**DEADLINE 9 RESPONSE**

**KENT DOWNS AONB UNIT RESPONSE TO**

**APPLICANT'S SUBMISSIONS AT DEADLINE 8**

**9.192 Applicants Responses to the Examining Authority's**  
**Third Written Questions (ExQ3) [REP8-115](#)**

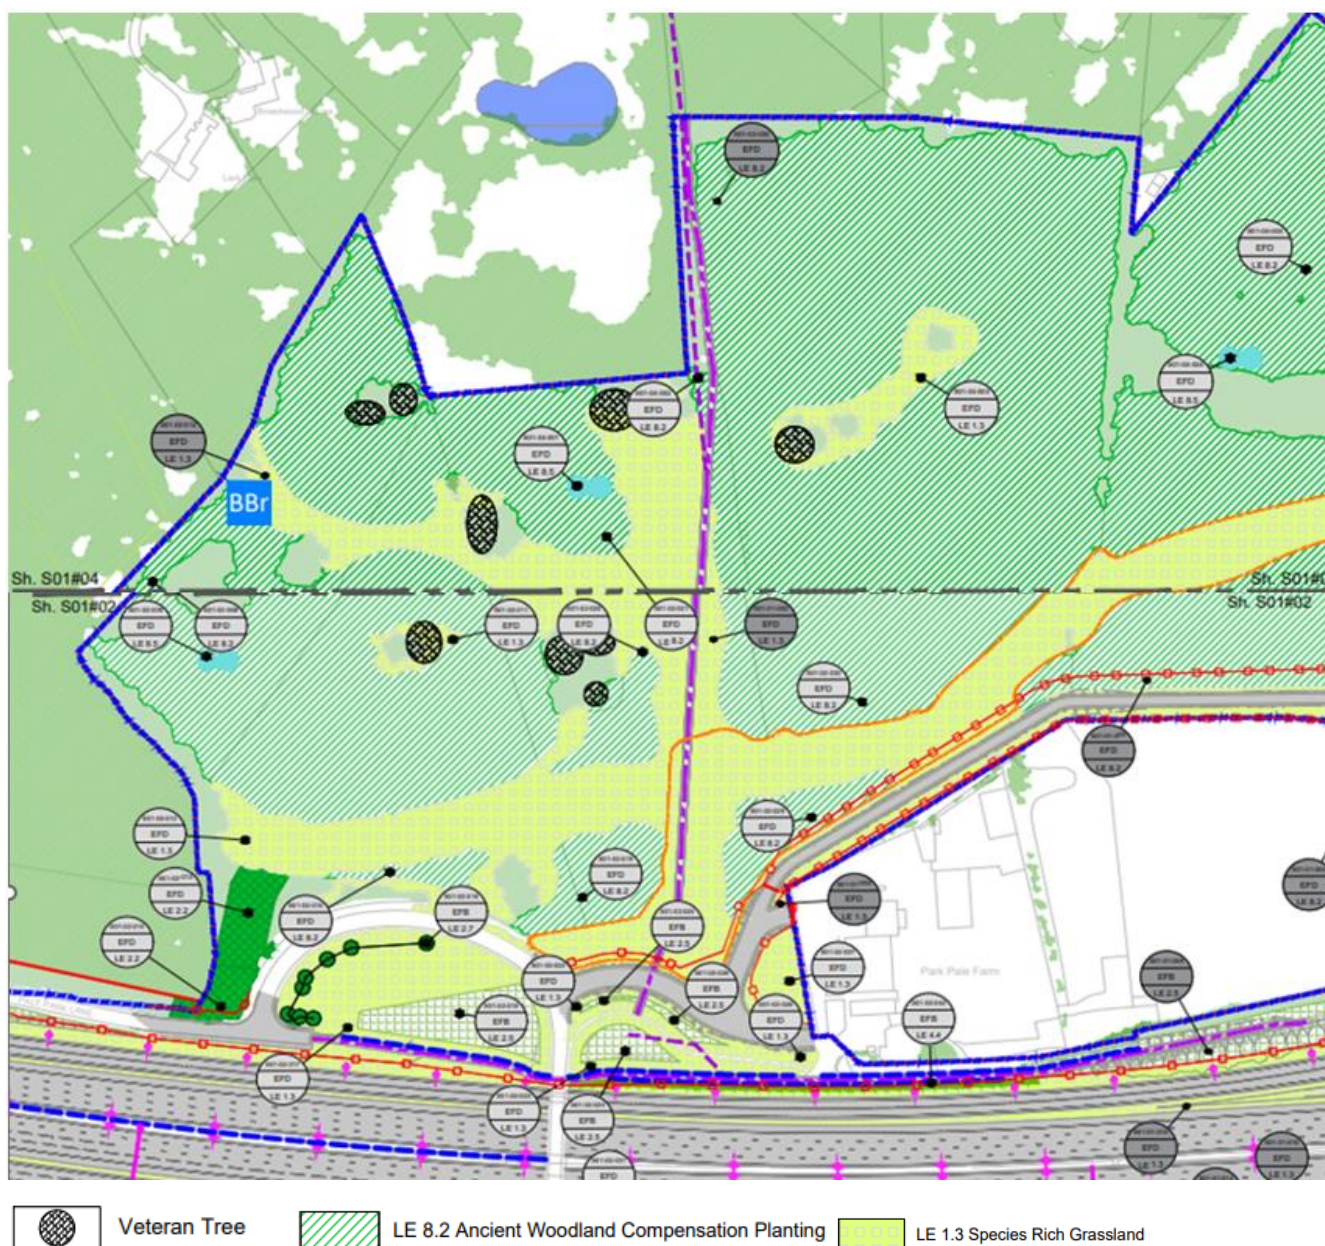
The AONB Unit strongly contests the assertion set out in the Applicant's response to this question that the existing individual and groups of trees that contribute to its historic parkland character 'would be set within an open ride/glade type character'.

The relevant extracts from Sheets 2 and 4 of the Environmental Masterplan for Sections 1 and 1A [REP4-124] reproduced below. As can be seen in these figures, the existing trees are almost without exception, subsumed either wholly within proposed new woodland planting or the new woodland planting would be located immediately adjacent to the retained trees, so that they would not be apparent as individual specimens or stands of parkland trees. As a result of this, the current historic parkland character would be lost.

characteristic of extensive areas of woodland and a strong sense of enclosure created by this woodland. It is on this basis, it is advised that *‘the proposed planting in this area is therefore not considered to be out of character for the West Kent Downs (sub area Shorne) LLCA.’* While the AONB Unit recognises that the West Kent Downs Sub area of Shorne LLCA is a generally wooded landscape, this justification is considered wholly inappropriate and fails to take into account the more nuanced specifics of the landscape character of this small part of the LLCA that makes a wholly positive contribution to the landscape and scenic beauty of this part of the AONB that would be lost as a result of the proposed compensation planting in this location.
